United States Department of the Interior

Enclosed is the determination of adequacy (DOA) review prepared for the Trail Mountain mine permit application package, concerning technical disciplines other than hydrology. Our DOA concerning hydrologic aspects was forwarded to you on September 1, 1983. These documents were prepared by our contractor, Simons Li and Associates, Inc., and have received an OSM review from our bonding, vegetation, soils, and wildlife specialists. Please review this document for interpretation of the Division's policy and regulations and forward it to the applicant within one week of receipt. OSM project leader, Louis Hamm, will contact your corresponding project leader, Pamela Grubaugh-Littig, shortly to discuss the Division's findings. In particular, the vegetation and reclamation sections should be carefully reviewed because of their particular significance in this application.

DETERMINATION OF ADEQUACY (DOA) - OTHER TECHNICAL DISCIPLINES

Figure 25. Land Use Map.

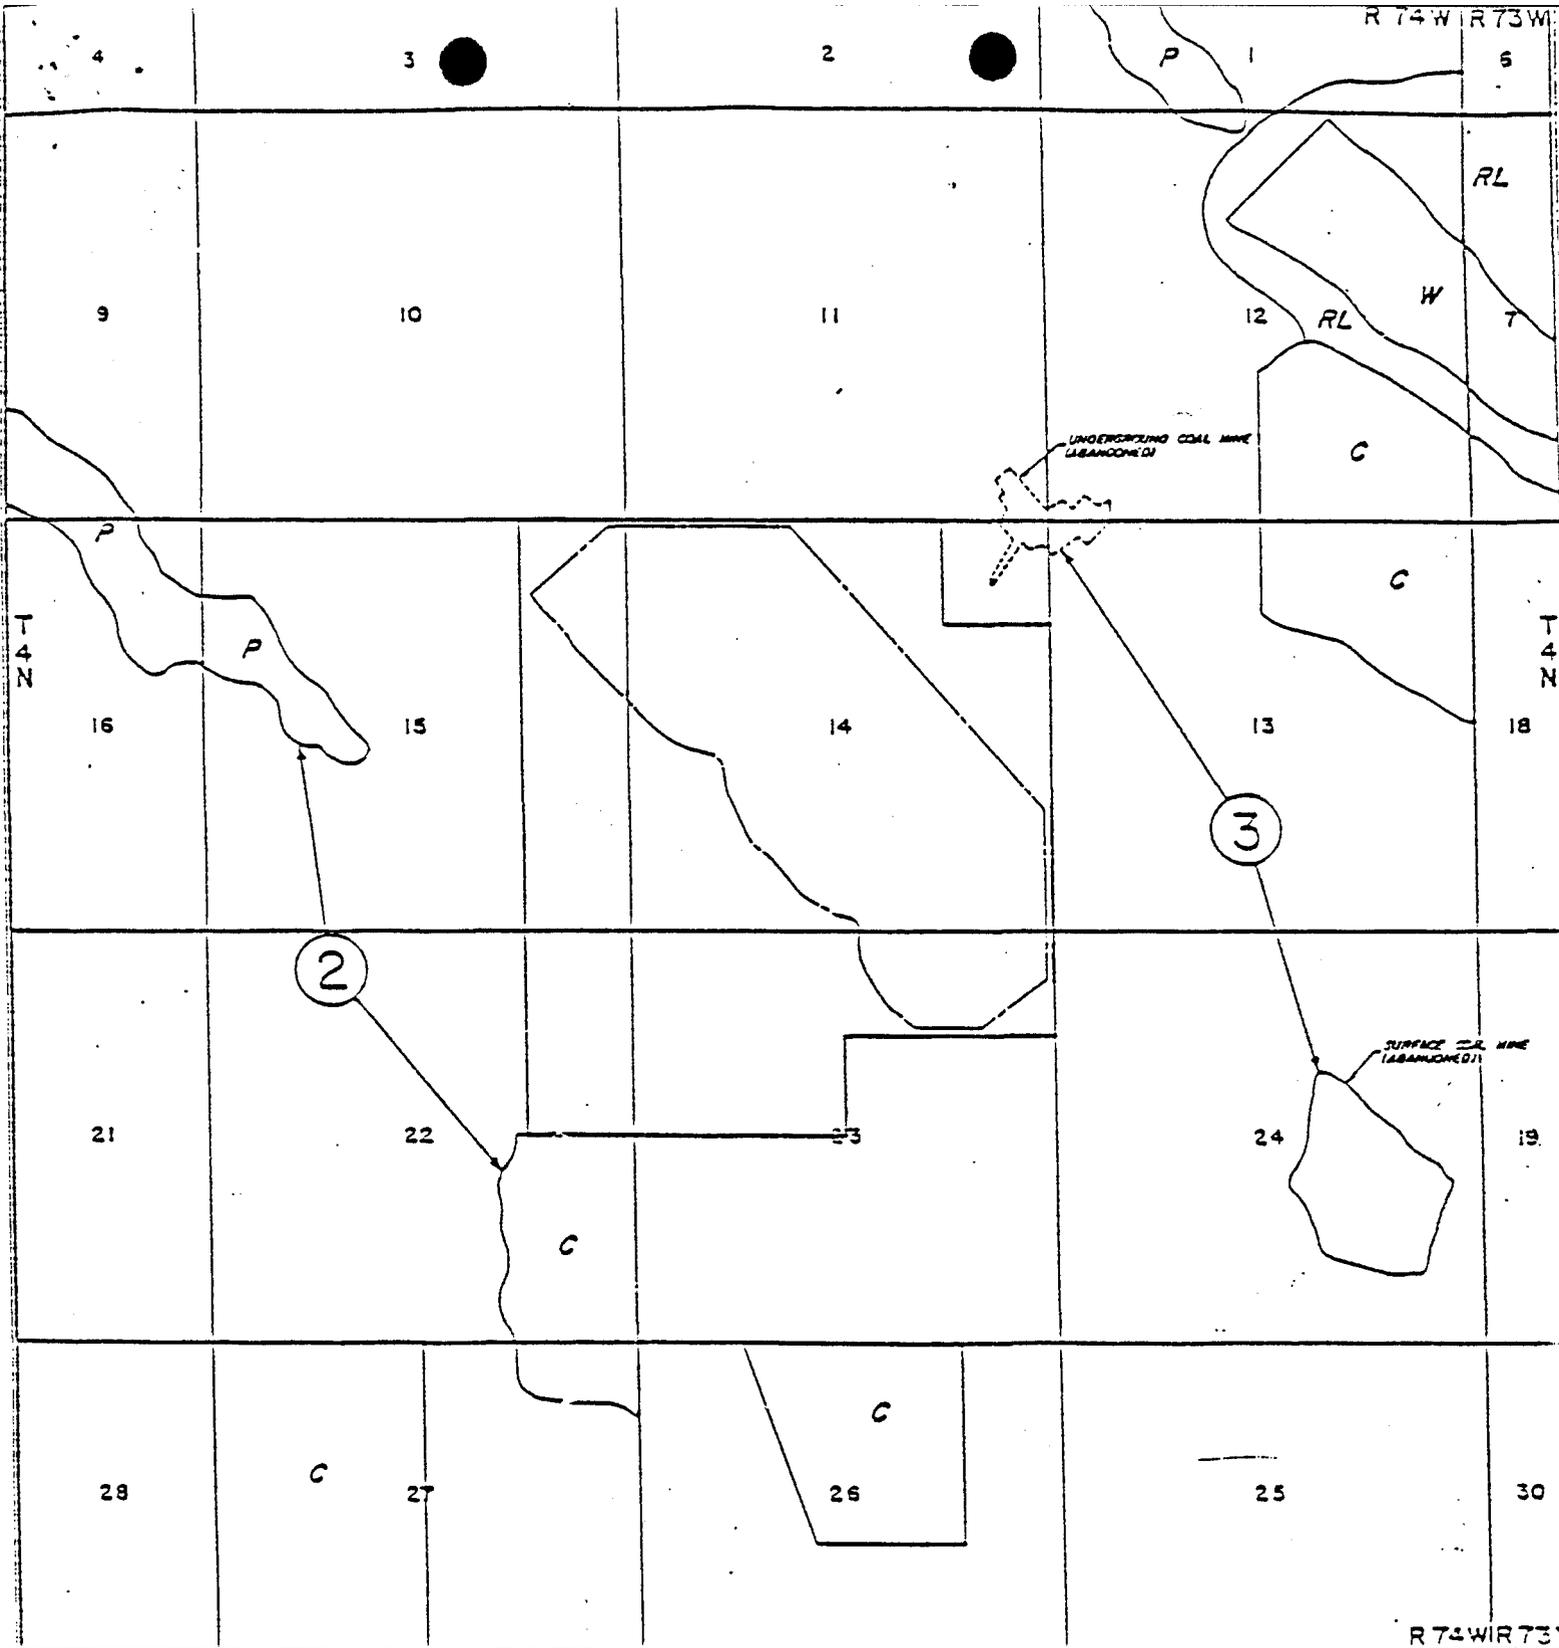
The applicant must supply a land use map [consistent with UMC 771.23(e) and UMC 783.24] showing boundaries of all land uses in the area including grazing allotments, fish and wildlife habitat, cropland, recreational areas, hunting units, etc., and locations of roads and previous mine workings. An example of an acceptable map format is provided in Appendix A. This section should reference the surface and mineral ownership map in the ACR response.

The land uses within the proposed permit area and adjacent areas should be identified on the Land Use Map. Land uses graphically illustrated on the map should be those existing at the time of filing the permit application and usually identified as one of the following:

The boundaries between the various land uses should be clearly marked on the Land Use Map.

Any previous surface or underground mining operations and the extent of their distrubance should be indicated on the Land Use Map. The permit application must contain the information for perviously mined-out areas as follows:
